# UNITED STATES PATENT AND TRADEMARK OFFICE

APPLICATION NO.	FILING DATE	FIRST NAMED INVENTOR	ATTORNEY DOCKET NO.	CONFIRMATION NO.
10/812,408	03/26/2004	Toshiyuki Kamiya	9319S-000745	1286
27572	7590	06/01/2005	EXAMINER	
HARNESS, DICKEY & PIERCE, P.L.C.			DOAN, THERESA T	
P.O. BOX 828			ART UNIT	
BLOOMFIELD HILLS, MI 48303			PAPER NUMBER	
			2814	
DATE MAILED: 06/01/2005

## Office Action Summary

## DETAILED ACTION

FIG.4F

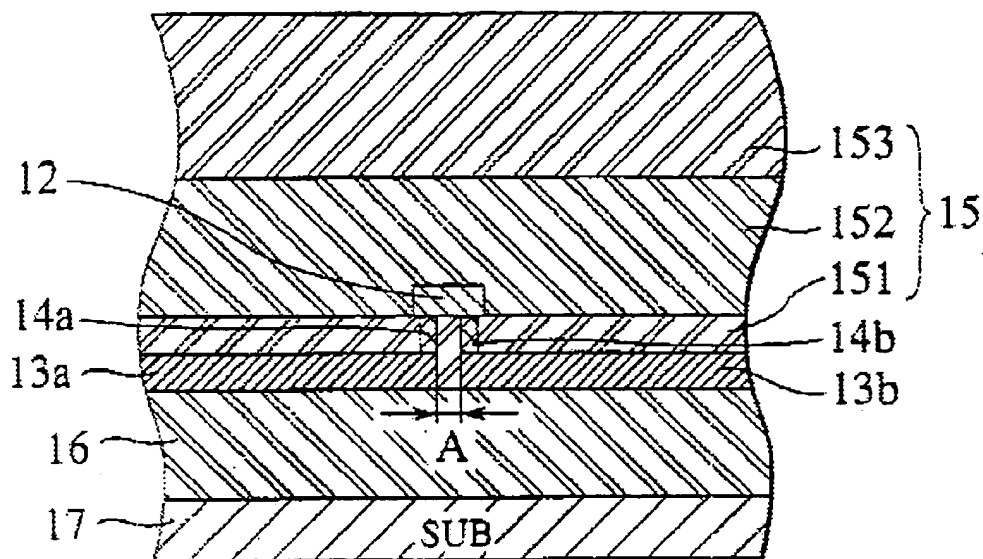
Regarding claim 1, Ohhashi (figures 4F-4G) discloses a semiconductor device comprising:

a fuse 12 including an upper layer wiring layer (column 10, lines 1-4);

a first protection film 152 on the fuse 12 (column 10, lines 1-4); and

a second protection film 153 on the first protection film 152 (see figure 4F and column 10, lines 6-7), the second protection film 153 including an opening section 11 formed therein that exposes the first protection film 152 (see figure 4G and column 10, lines 13-15);

the opening section 11 exposing an entire portion of the first protection film 152 located directly above the fuse 12.

- a step of forming a fuse 12 including of an upper layer wiring layer on an upper surface of an interlayer dielectric layer 151 that is formed on a substrate 17 (see figure 4F and column 9, lines 44-46);

- a step of forming a second protection film 153 on an upper surface of the first protection film 152 (see figure 4F and column 10, lines 6-7); and

FIG.4G

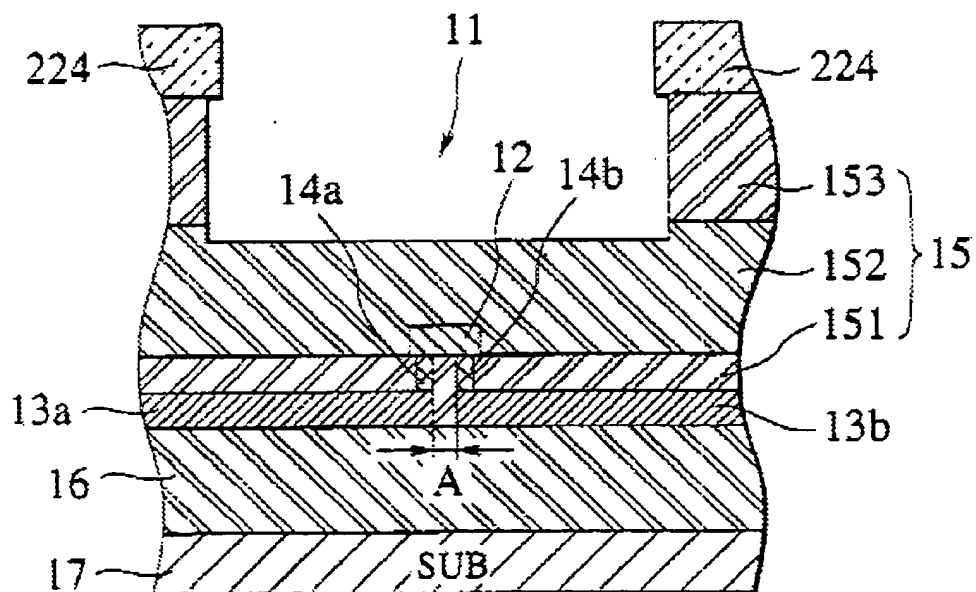
Regarding claim 2, Ohhashi (figure 4G) further discloses that each of two end sections of the fuse 12 is connected to a lower layer wiring layer (13a and 13b) through a via hole (14a and 14b) (also see figure 5A).

- a step of forming the opening section 11 in the second protection film 153, the opening section 11 that exposing an entire portion of the first protection film 152 located directly above the fuse 12 (see figure 4G and column 10, lines 13-15).

Regarding claim 4, Ohhashi (figure 4G) further discloses the steps of forming via holes (14a and 14b) in the interlayer dielectric layer 151, and connecting two ends of the fuse to a lower layer wiring layer (13a and 13b) through the via holes (14a and 14b) (also see figure 5A).

- a substrate 17 (column 6, line 23);
  - a fuse 12 disposed on the substrate 17, the fuse 12 including an upper layer wiring layer (see figure 4F and column 10, lines 1-4);
  - a first protection film 152 disposed on the fuse 12 (column 10, lines 1-4); and
  - a second protection film 153 disposed on the first protection film 152 (see figure 4F and column 10, lines 6-7), the second protection film 153 including an opening 11 formed therein that exposing the first protection film 152 (see figure 4G and column 10, lines 13-15);
- the opening section 11 having a width at least equal to a width of the fuse 12 (see figure 4G).

Regarding claims 6-7, Ohhashi further discloses that the opening section 11 extends outboard of the fuse 12 and the opening section 11 includes bottom end portions outboard of the fuse 12 (see figure 4G).
